**Our Case Number:** ABP-314610-22

**Re:** BusConnects Ballymun/Finglas to City Centre Core Bus Corridor Scheme  
Ballymun/Finglas to Dublin City Centre

**Re: Case Number HA29.314610 - Ballymun/Finglas Route of Bus Connects**

Appendix 1: Map image of the stretch of road between Botanic Avenue and Fairfield Road, along Saint Mobhi Road (“The Southern Mobhi Road Section”, “The SMR Section”)

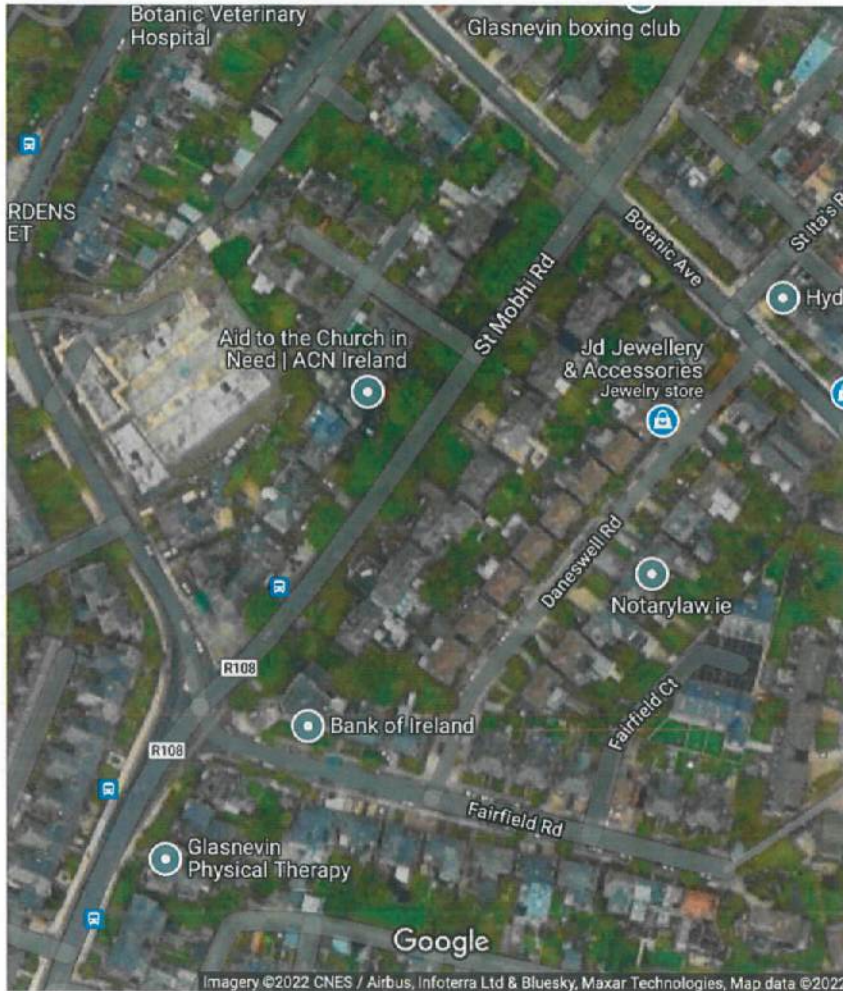
- The above mentioned section is currently servicing 2 general traffic lanes plus 1 dedicated cycle track (see appendix 2 for Google Street image).

- The width of the road is restricted by the mature trees which currently border and bulge onto the existing road, especially on the southbound cycle track.

- The addition of the bus lane will mean the space and clearance of cars along this stretch will be very narrow, considering the large vehicles (buses, HGVs, etc.) which currently pass the road will certainly lead to accidents.

- Move Signalled Controlled Priority light from corner of Mobhi Rd and Fairfield Rd to the corner of Mobhi Rd and Botanic Avenue. This will still ensure bus priority along this 200m stretch of the road.
- Insert bike lanes on both sides of the road, on the existing road. This will significantly reduce any landscape and visual impact on Saint Mobhi Rd.
- As there will be no bus lane between Fairfield Road and Marguerite Rd, the lack of a bus lane on this stretch will not improve/disimprove current traffic flows, due to the bottleneck less than 200m up the road.
- Consideration needs to be given of the cost which would be incurred plus environmental impact.
- Consideration needs to be given to impact of the proposed works on the trees on the SMB Section
